# Public Hearing Appeal Submission

**LOC2024-0183**

**(DP2024-06339, 206, 210, 214, 218 19  
Street NW)**

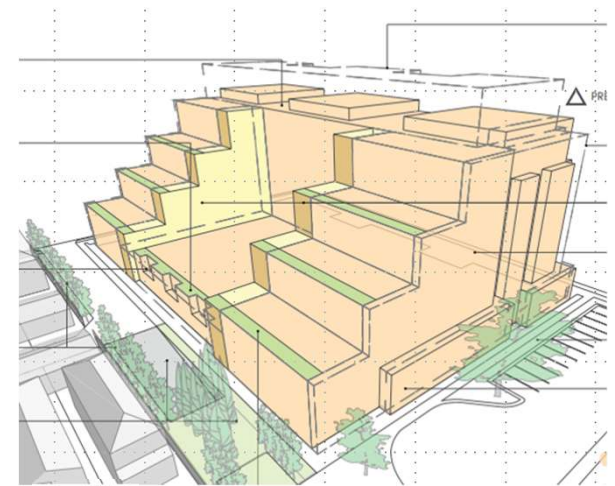
- **The Application lacks materially significant massing shifts and cutouts from similar developments in the areas (and the Applicants own adjacent development)**

(above) Applicant's previous "19+2" (left half) and "West 19<sup>th</sup>" (right half) Development showing non continuity of massing shifts, and non-contiguous cutouts on West 19<sup>th</sup>

(above) Massing Shifts on Truman Homes Kensington Redevelopment (see Appendix A for additional details)

(right) East Elevation of Massing Shifts, Cutouts, and Stepbacks on Applicant's Adjacent 19+2 Development

**Applicant's Previous Massing Shifts Should Be Continued On This Application**

December 21 4:00pm

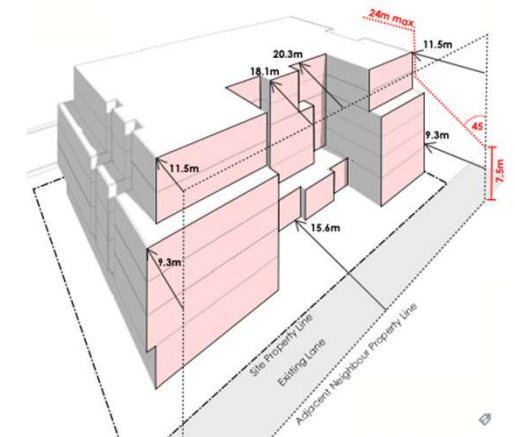
- The massing shifts and cutouts of this application are materially insignificant and do not provide sufficient transitions for shadowing impact
  - ✓ Shadow studies indicate a prevailing impact on the properties to the NE of the Application past 4pm
  - ✓ The proposed courtyard **cut-out would need to be the full-width** of the building to be effective in providing relief
  - ✓ 5<sup>th</sup> / 6<sup>th</sup> floor step backs are insufficient to achieving scale transitions

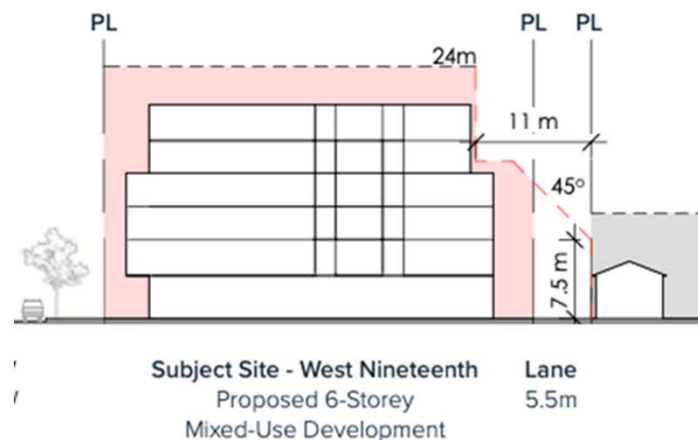
(above) Illustrative guidance from the Riley LAP showing meaningful step-backs above the 3<sup>rd</sup> storey

(above) Cross-section of Application showing **failure to step back at the 3<sup>rd</sup> storey** and the immaterial stepbacks / massing shifts creating insensitive transitions to the adjacent 18A St NW properties

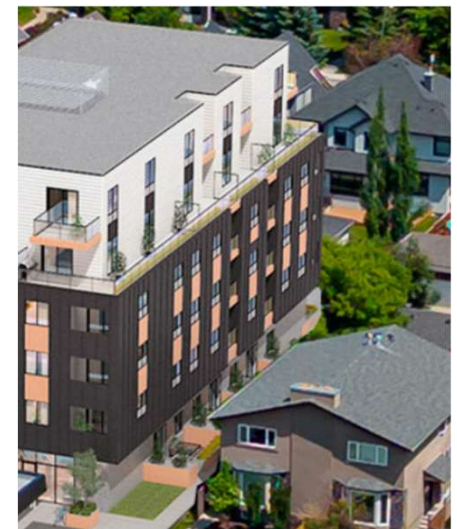
(right) Dwellings immediately to the south of the Application have north facing windows and entrances that will be affected by this development

(right) Dwellings immediately to the south of the Application will not have meaningful setbacks and will have insensitive transitions in scale.
